**Proposed Composite Development (with Flat and Retail/F&B)
with Minor Relaxation of Plot Ratio Restriction
in "Commercial (2)" Zone at 8 Lam Chak Street, Kowloon
- S16 Planning Application –
TPB Ref.: A/K22/50
Further Information No. 2**

(Planning Application No: A/K22/50)

RESPONSE-TO-COMMENT TABLE

TITLE	標題
INDICATIVE SECTION A-A

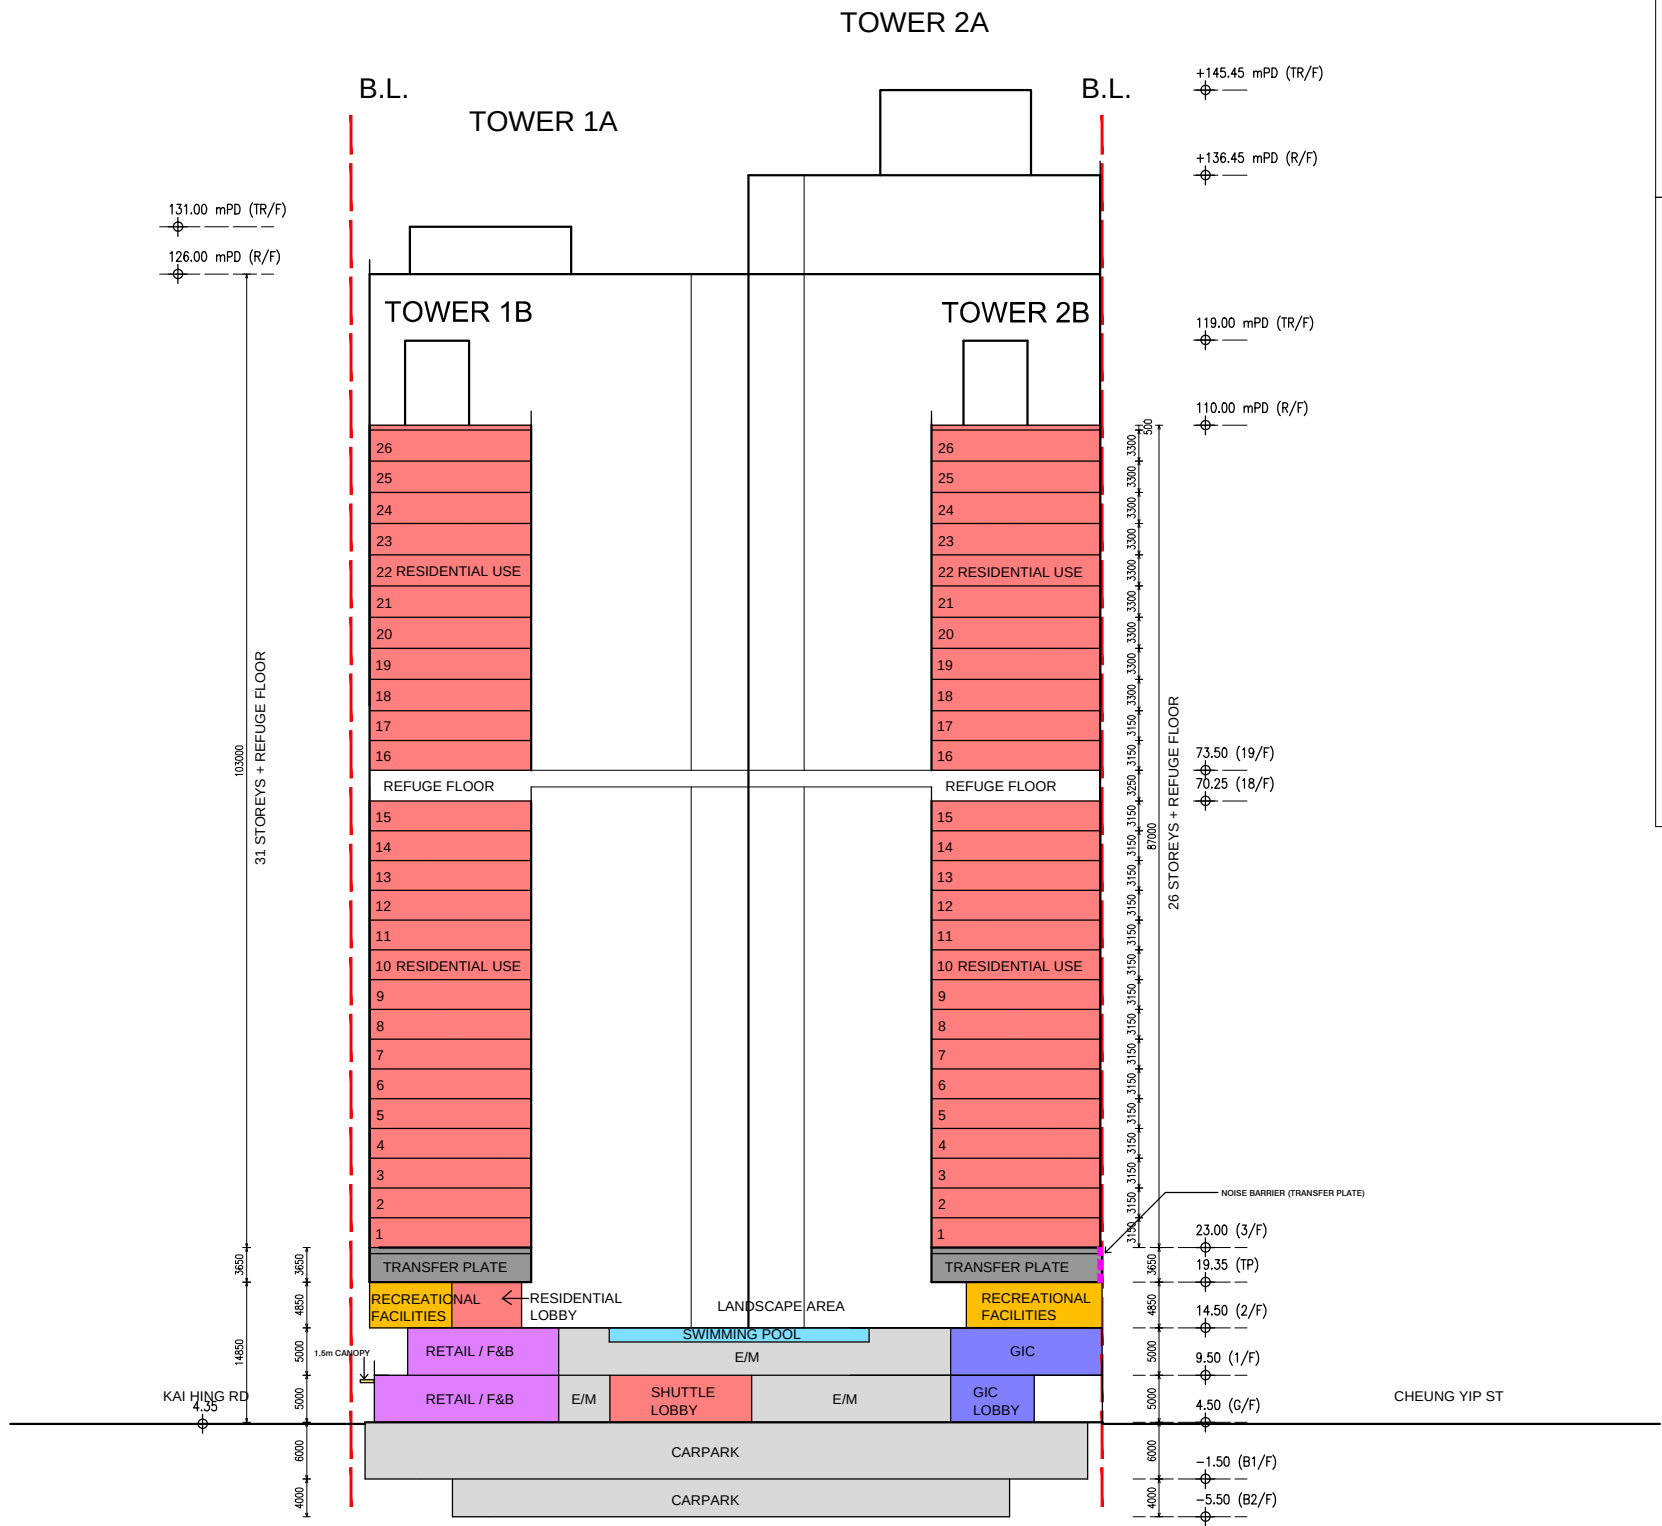
10. <i>Drawing Nos. LD101, LD102 and LD103</i>: Please add ‘Edge Planter with creeping plants’ on plan along 1/F facing public street to align with the updated Drawing No. LMP03. Please advise if there are any greenings on roof floors of Towers 1A, 2A and 2B as shown on Indicative Sections A-A and C-C.	Dwg. No. LD101, LD102 and LD103 has been revised accordingly (<i>Appendix II</i> refers). Please be confirmed that there would be no greening on roof floors of Towers 1A, 2A and 2B. The Indicative Section A-A and C-C have been revised.

DRAWING No. LMP01

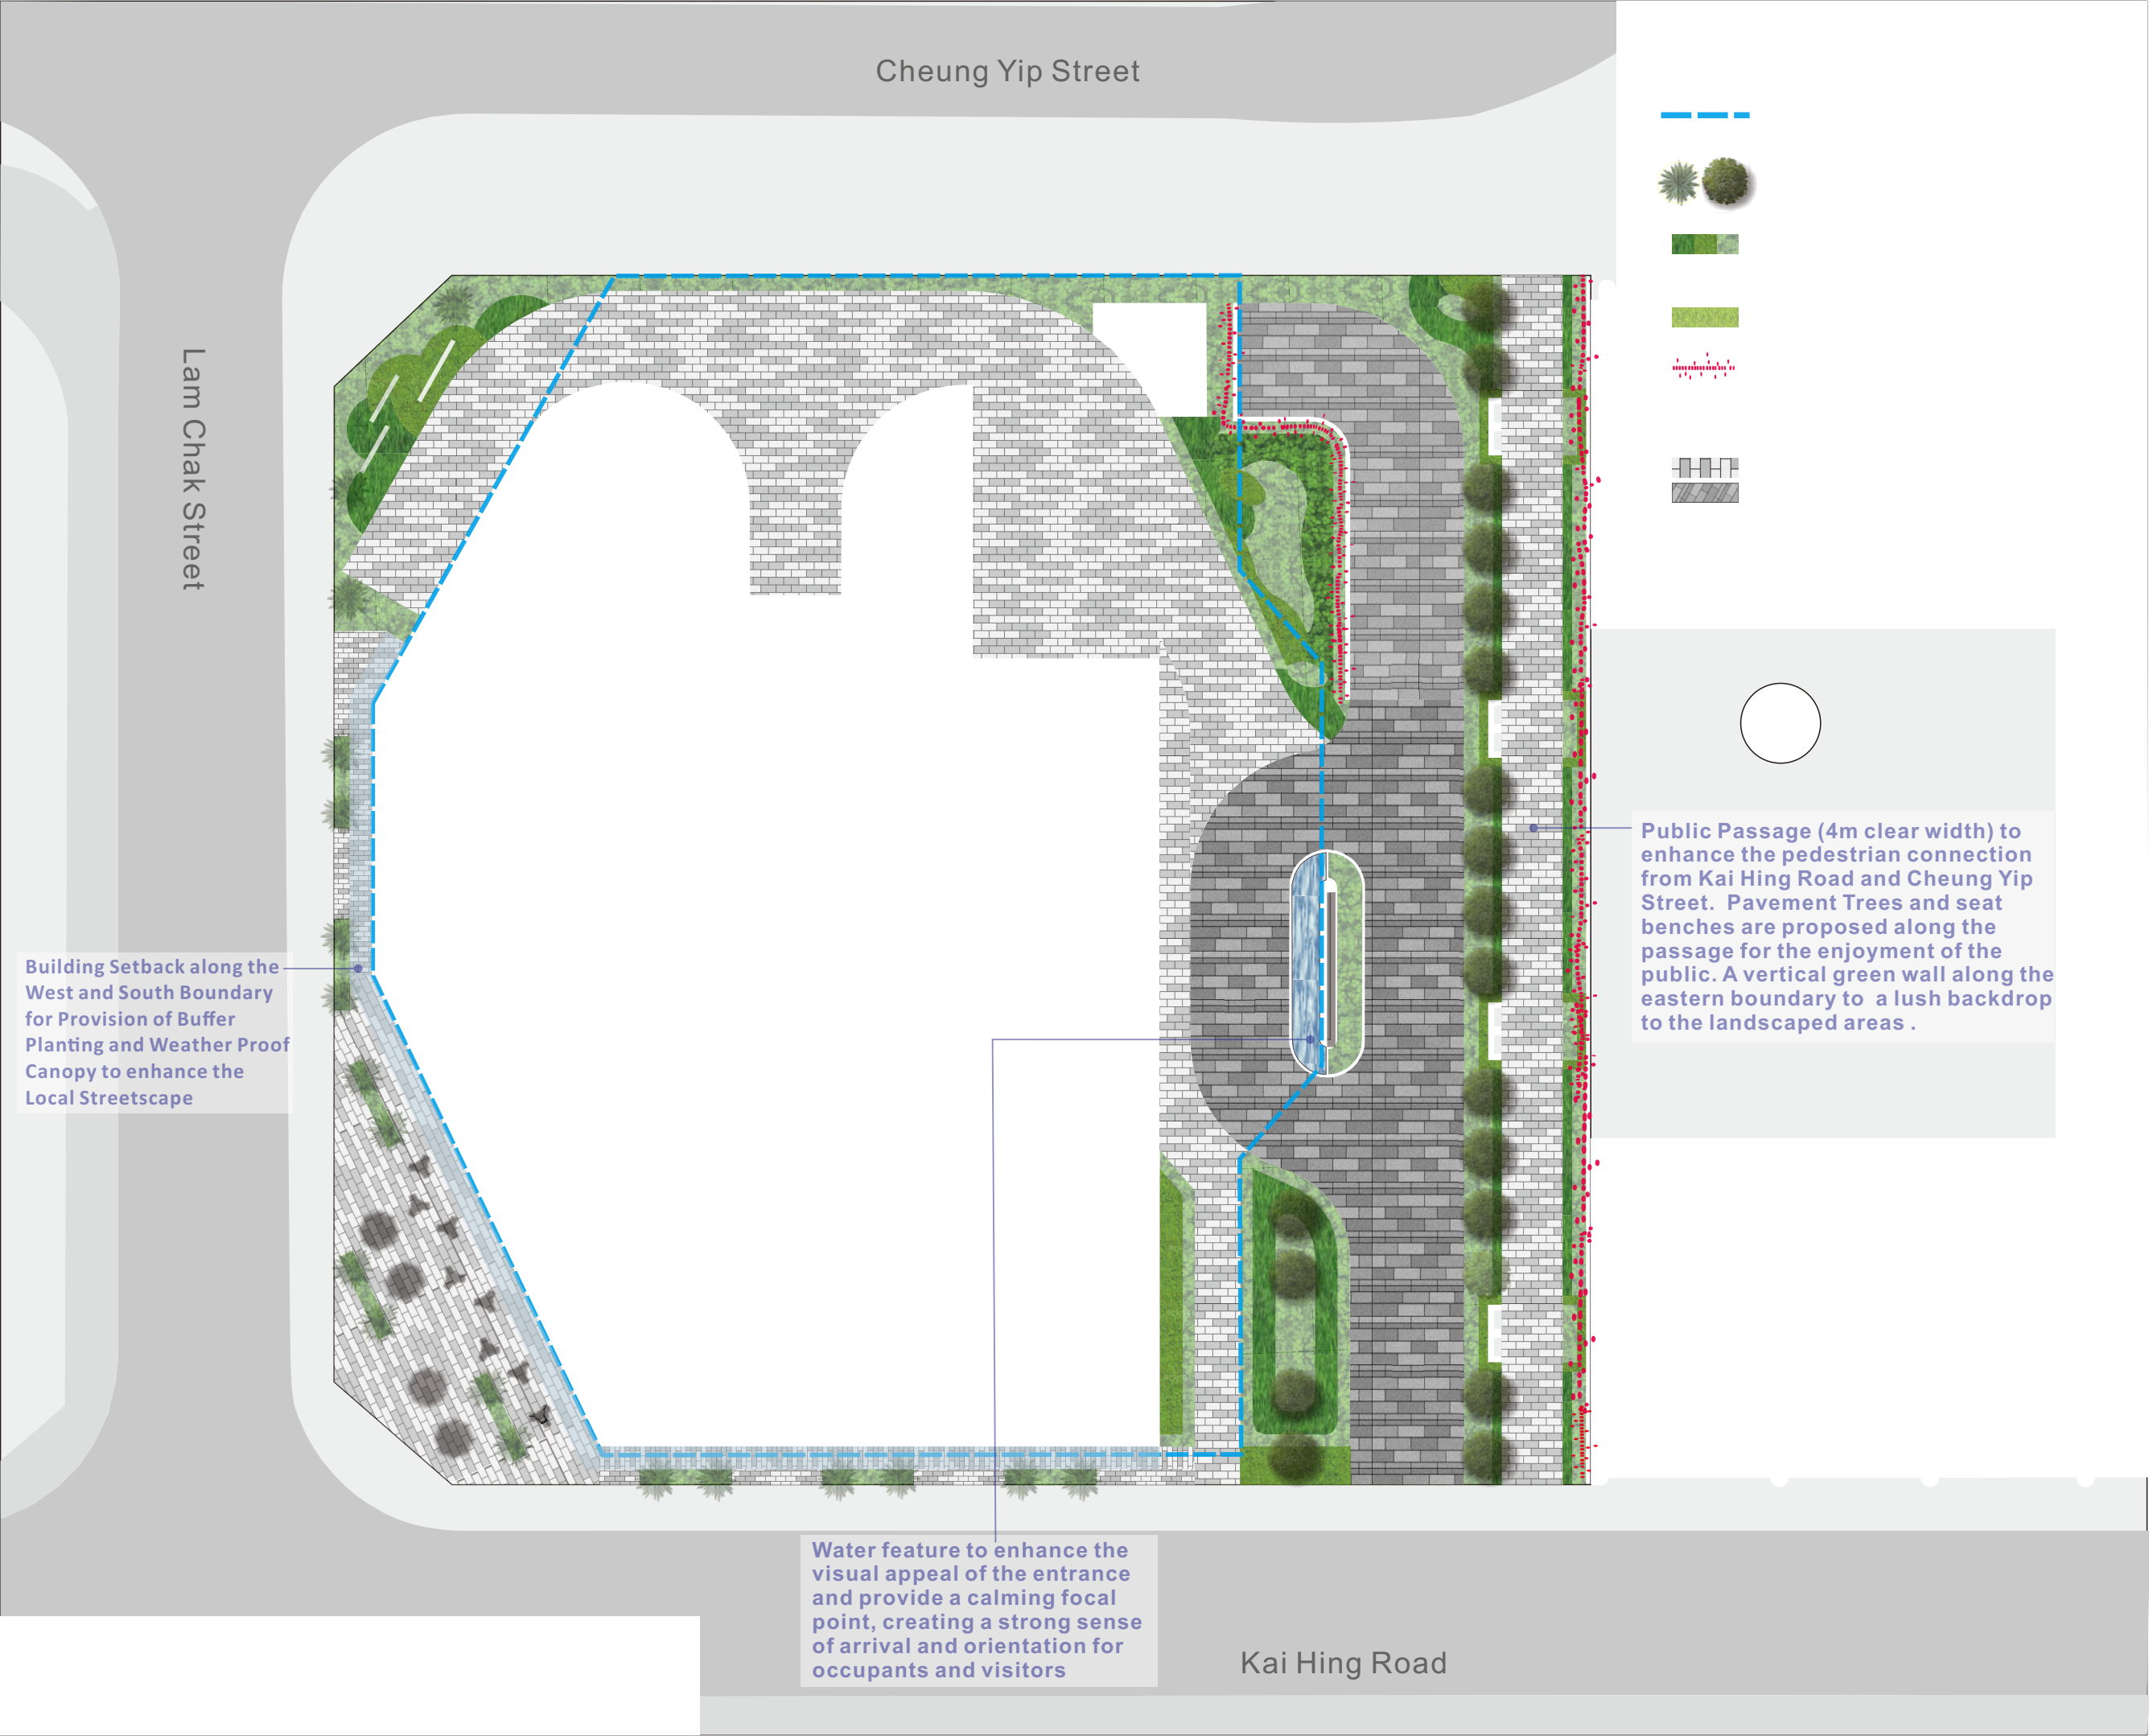
Comments	Response
<u>Specific Comments on Drawings</u> Please note the following plans have yet been updated/provided in this FI submission. <i>Ground Floor Plan</i> ” 4. Despite the R-to-C Pg.12, item 5, the revised G/F plan is not provided. Our previous comment on the level of “Shuttle Lobby remains valid. <i>Indicative Master Layout Plan and Ground Floor Plan</i> 5. In relation to our comments above on the corner splay area and 4m-wide public passage, please review if the colour/legend is accurate and advise if these areas are intended to serve as circulation space. <i>Roof Floor Plan</i> 6. Please also indicate the roof area of podium and shuttle lobby on this plan. <i>Indicative Sections B-B and C-C</i> 7. In view of the changes to the roof top structures indicated on the revised MLP, please review the roof top structures at Tower 2A. <i>Landscape Proposal</i> 8. <i>Drawing No. LMP01 Landscape Master Plan (Overall View):</i> The keys for No. 16 to No. 18 are still missing noting that their annotations remain on plan. The roof level of “Shuttle Lobby is incorrect. The	result in any changes to the junction performances. Not least, the overall conclusion (i.e. reduce traffic to the nearby road network) remains unchanged. ” The level of the “Shuttle Lobby has been amended (<i>Appendix I</i> refers). The MLP and G/F Plan have been amended (<i>Appendix I</i> refers). The Roof/F Plan has been amended (<i>Appendix I</i> refers). Sections B-B and C-C have been amended (<i>Appendix I</i> refers). Drawing No. LMP01 has been amended (<i>Appendix II</i> refers).

DRAWING No. GC01

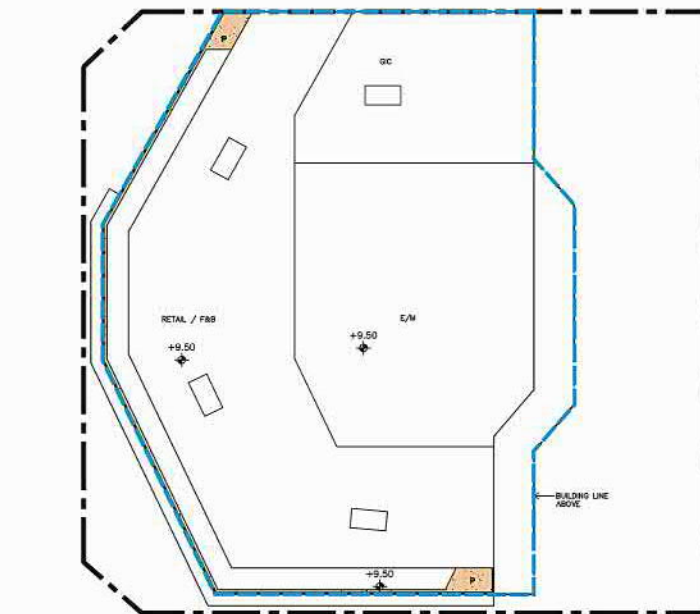
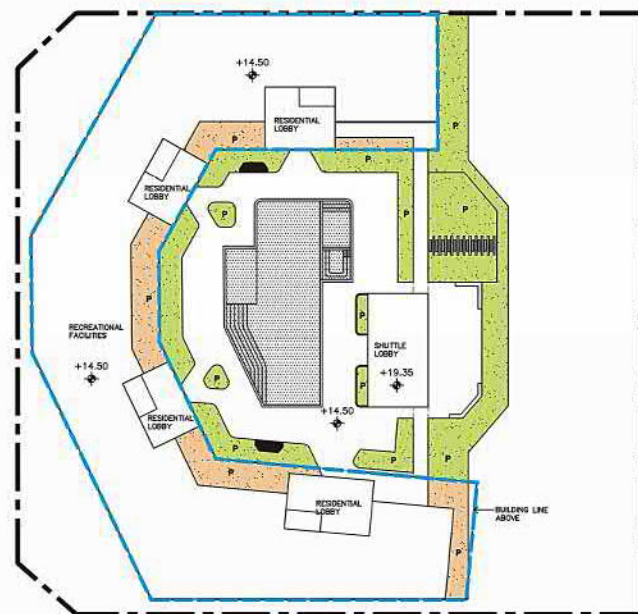
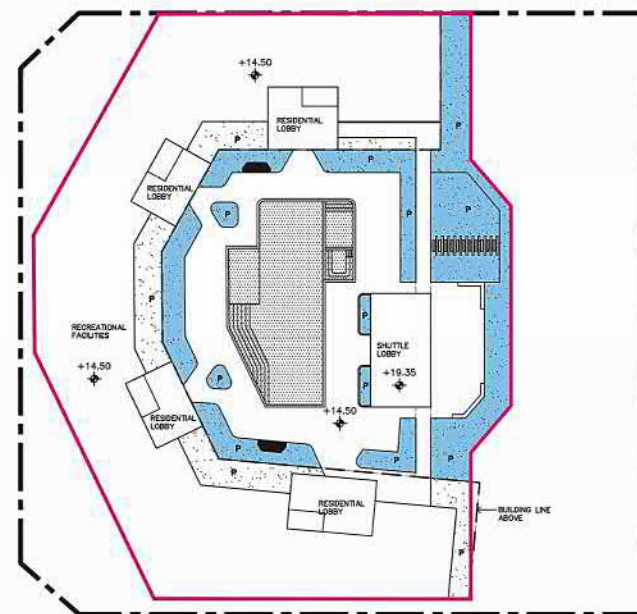
11. <i>Drawing No. GC01 Greenery Provision</i>: It is noted that on 2/F, the greening area of about 633.7m² and covered planting area of about 123.5m² have been counted in both the greenery calculations at the primary zone and roof greening. Please note that provisions should not be double counted. Moreover, greenings on roof floors of Towers 1A, 2A and 2B are shown on Indicative Sections A-A and C-C but not shown on this greenery provision plan. Given it is a usual practice that details on greenery are finalized and provided at the detailed design stage which would be reflected on general building plans, for this s16 submission please (i) only show the ‘uncovered greenery at primary zone’, ‘covered greenery at primary zone’ and ‘greenery at roof’ and remove all the numbers showing their areas; (ii) update the colour for the greenery at 2/F which would either be counted at primary zone or at roof (for uncovered part); (iii) include greening provisions on roof floors of Towers 1A, 2A and 2B; and (iv) provide a summary table on this plan to show the provisions as stated in Para. 5.2 of the Landscape Proposal (extracted below).	For Drawing no. GC01, the detail on greenery has been deleted and they will be subject to detailed design. Summary table of the greenery provision as stated in Para. 5.2 has been added. With regard to roof greenery, it is confirmed that no greening is proposed on the roof floors of Towers 1A, 2A and 2B, and Indicative Sections A-A and C-C have been revised accordingly. In the absence of a clear definition of roof greenery in the Explanatory Statement, the proposed roof greenery will be provided on the podium roof as part of the accessible landscaped area. Covered greenery at the podium has also been excluded from the greenery calculation to avoid double counting and ensure consistency with Drawing No. GC01 and the revised Landscape Proposal.
